CLIENT:	Jones Homes (Yorkshire) Limited
PROJECT:	Land at Primrose Lane, Liversedge
SUBJECT:	Technical Response to Coal Authority Objection
JOB NO:	LD11032
DATE:	18 th September 2024
PREPARED BY:	Jonathan Currie (Wardell Armstrong, Associate Director)
CHECKED BY:	Abdul Rehman (Wardell Armstrong, Regional Director)

This Technical Note (TN) has been prepared by Wardell Armstrong (WA) to address the substantive concerns raised by the Coal Authority (CA) pursuant to Local Planning Authority number 2023/62/91116/E for the proposed development of 77 dwellings at land off Primrose Lane, Hightown, Liversedge (the Site).

Appendix A – Drawing LD11032-001 Mine Shaft Zone of Influence Drawing

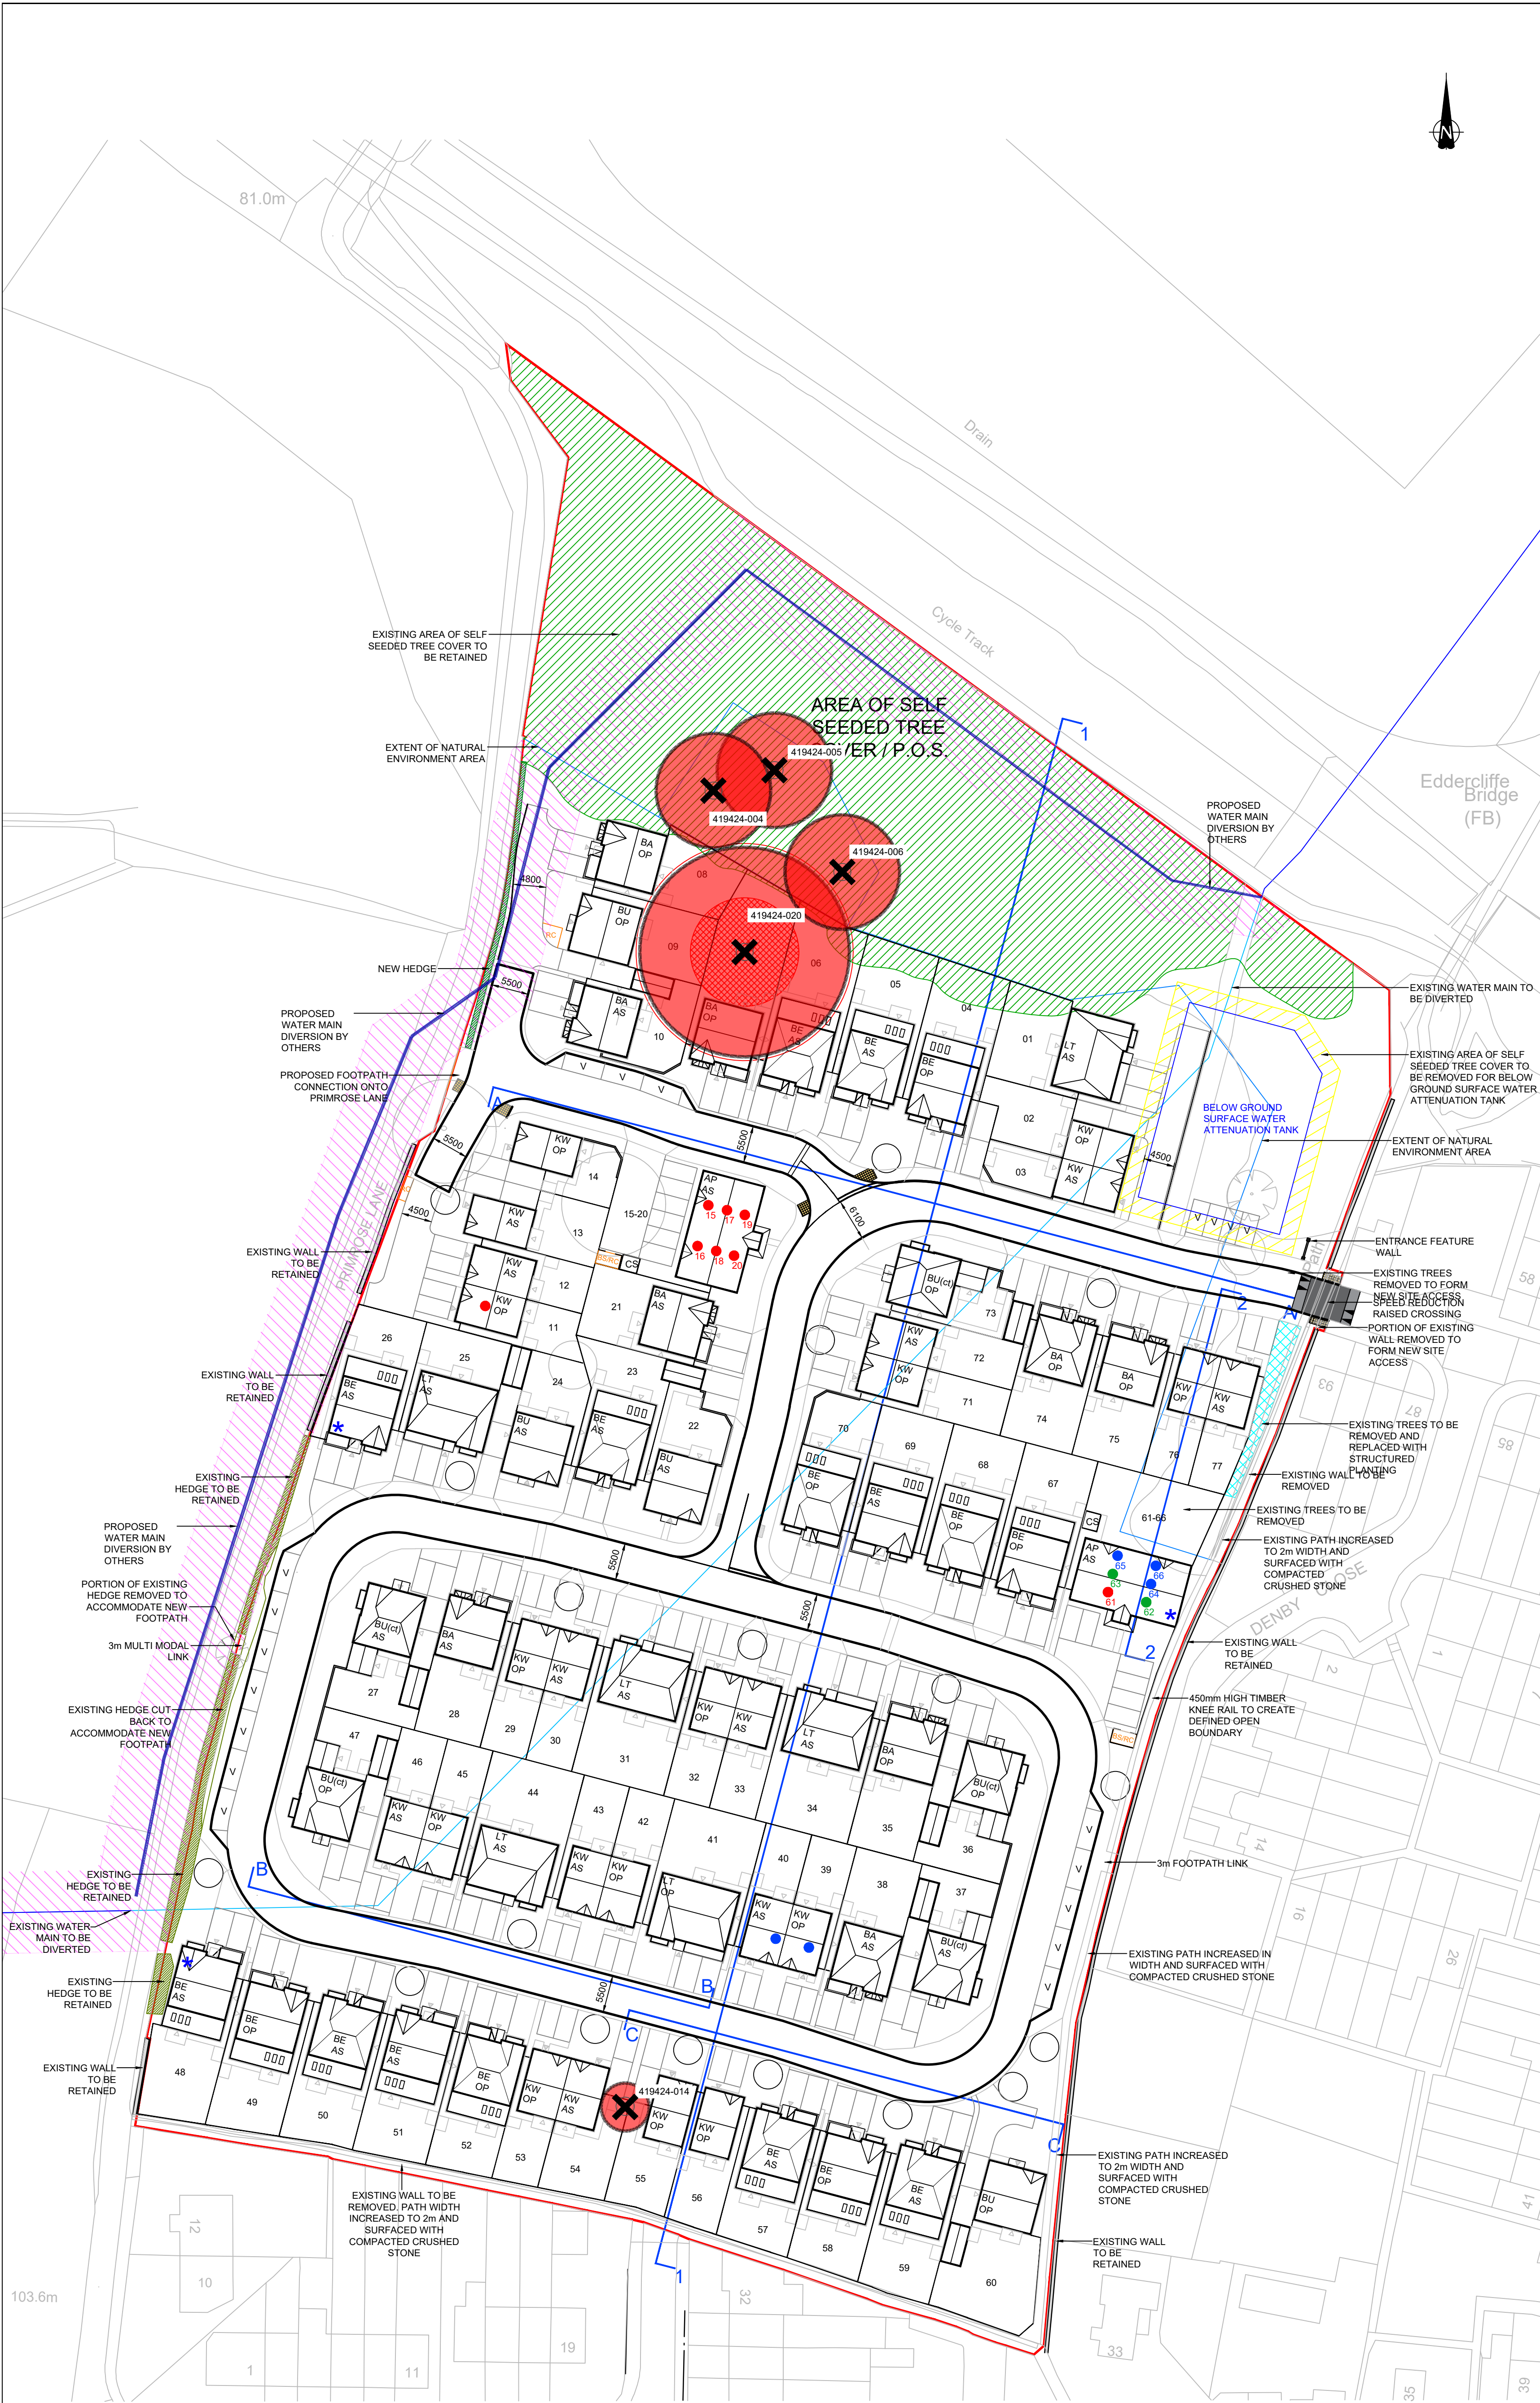
The CA's objection, as detailed in their response dated 5th July 2023, primarily relates to concerns that the proposed development layout has not been sufficiently informed by the presence of the mine shafts and their potential zones of influence (ZOI). Other key issues that were raised included the potential for shallow, unrecorded coal mining activity beneath the Site, which may lead to voids, ground instability, and the risk of mine gas emissions.

It was advised that further intrusive investigations would be required to locate all the recorded mine entries within the Site, including establishing the adequacy of any past treatment works. The findings should then be used to revise the proposed development layout to ensure that the built development avoids the mine shafts and their associated ZOI's.

Drawing LD11032-001 shows that the mine entries 419424-004, 005, 006 and their ZOI are located outside of the built development area. Furthermore the Yorkshire Water Main Diversion has been rerouted to avoid these mine entries. Given that the shafts are now located within an undeveloped area, the area is to remain woodland and that the shafts are capped and treated, these mine entries pose a very low risk to the proposed development.

While the ZOI of mine entry 419424-004 is located close to Plot 08 it should be noted that a precautionary 1m departure has been included within the ZOI calculation, even when the use of a 0m departure would have been justifiable. Furthermore, due to the deep Made Ground that is present within this area, it is understood that piled foundations to competent rockhead and suspended floor slabs would be required. In the unlikely event that the shaft were to collapse, the most likely mode of failure would be at the intersection where the shaft meets rockhead, with the collapse primarily occurring in the overlying fill material. The impact of such a collapse on a structure with the above structural precautions would be significantly reduced.

Drawing LD11032-001 shows that this mine entry and its ZOI are no longer located beneath a building and are now restricted to the garden areas of Plots 54 and 55. While the mine entry and its ZOI are still located close to residential dwellings, several factors significantly reduce the likelihood of any major instability.

Drawing LD11032-001 shows that the mine entry is located within garden area of Plot 07 and the proposed development has been amended so that the majority of the ZOI is now restricted to the garden areas of Plots 06 – 10. While Plots 06 and 07 are still located within the wider ZOI, the proposed development has been carefully amended to ensure that they are not located within this mine entries departure radius.

The primary objective of this TN is to address and remove the objection raised by the CA, specifically by ensuring that no buildings are located over recorded mine entries. The proposed development layout has been amended accordingly, ensuring it is informed by the known mining legacy features.
